**SERVICING DESIGN BRIEF
AND
STORMWATER MANAGEMENT
REPORT**

1420 EARL ARMSTRONG ROAD

**SITE PLAN APPLICATION
FILE No. DO7-12-14-0067**

Technical Comments – Feb 24, 2017

**STORMWATER MANAGEMENT
DRAINAGE AREA PLAN**

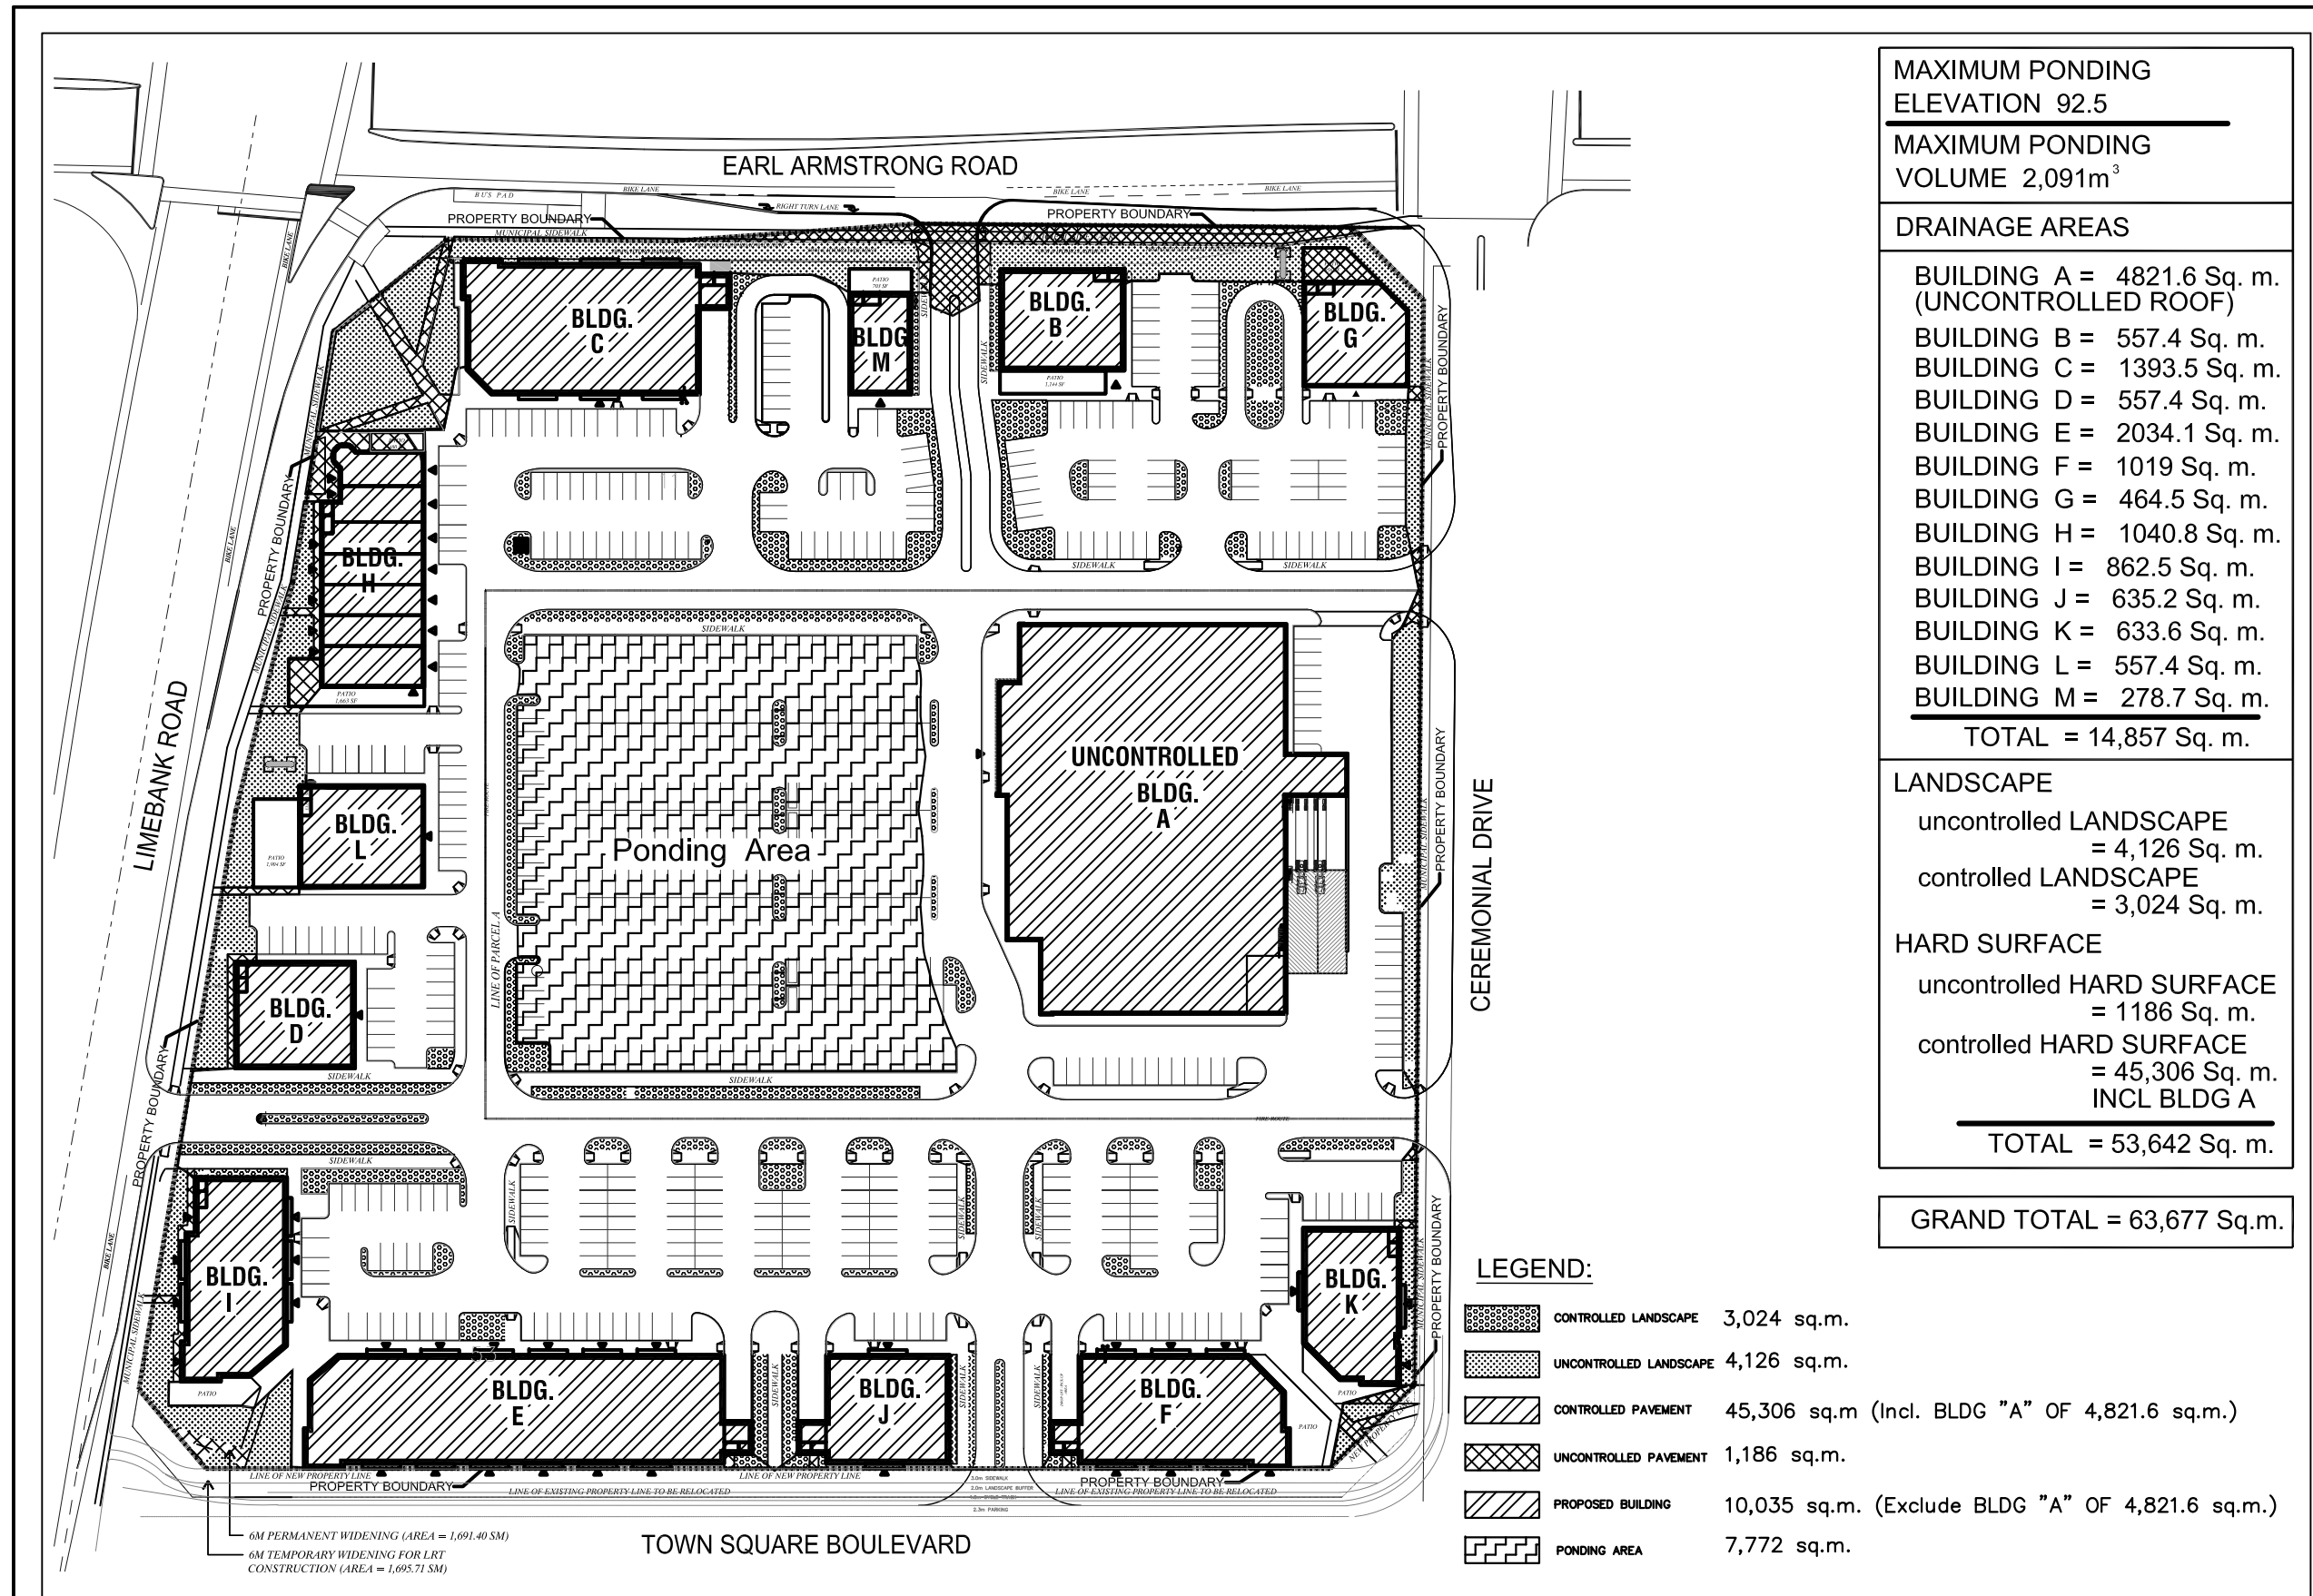
- Separate the flows going into the existing CB inlet south of the future Town Square Boulevard and the flows north of Town Square Boulevard. The flows should be based on the Sewer Design Guidelines – minor system for 10 year return period. The table needs to be rectified for the external flows on the second page. May you should use a different table for clarity purposes. If you need the plans to show the drainage from Limebank, please let me know.

10. You are only required to show one example of detailed calculations, but you must provide the storage tables for each catchment area including the roof tops and surface storage. This is required to determine the storm sewer design sheet. – The rooftop storage tables should be done for each roof, not all roofs combined. You can use the same table for roofs with the same shape and area. (i.e. roofs buildings D and L).

Response: *External plan revised to reflect design sheet.*

Response: *On drawing 3 of 8, SWM Drainage Plan, we have summarized the surface ponding volume for each catchment area, during the 1:100 year storm event. We have also summarized the roof ponding volumes for each of the controlled buildings, during the 1:100 year storm event.*
